UNITED STATES PATENT AND TRADEMARK OFFICE

APPLICATION NO.	FILING DATE	FIRST NAMED INVENTOR	ATTORNEY DOCKET NO.	CONFIRMATION NO.
10/529,347	12/20/2005	Marco Castello	82062-0150	6682
24633	7590	03/15/2010		
HOGAN & HARTSON LLP IP GROUP, COLUMBIA SQUARE 555 THIRTEENTH STREET, N.W. WASHINGTON, DC 20004				
EXAMINER				
LEO, LEONARD R				
ART UNIT		PAPER NUMBER		
3744				
NOTIFICATION DATE		DELIVERY MODE		
03/15/2010		ELECTRONIC

Office Action Summary**Application No.**

DETAILED ACTION

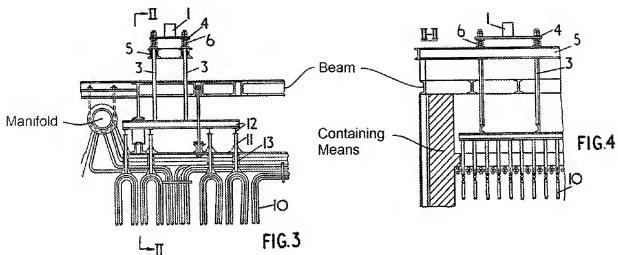
Claims 1, 3, 5-6, 9-16, 18 and 20 are rejected under 35 U.S.C. 102(b) as being anticipated by Kropp et al (GB 1,099,742). Figures 3-4 of Kropp et al discloses a heat exchange unit comprising a tube bundle 10 for heating water; containing means for a heating gas defined, in part by unlabelled vertical walls into which the bundle 10 extends (Figure 4, marked up below); and connection means 5 operatively connected to the upper end of the tube bundle 10 and structurally separate from the containing means.

Regarding claim 9, Figures 3-4 (marked up, next page) of Kropp et al discloses the heat exchange apparatus including an unlabelled manifold connected to the tube bundle 10 is vertically supported by an unlabelled beam, which in turn is supported on top of the containing means.

Regarding claims 10-11 and 13, Figures 3-4 (marked up, above) of Kropp et al discloses an unlabelled separating plate/frame (i.e. a brick lining) with seals 13 partially crossed by the tube bundle 10.
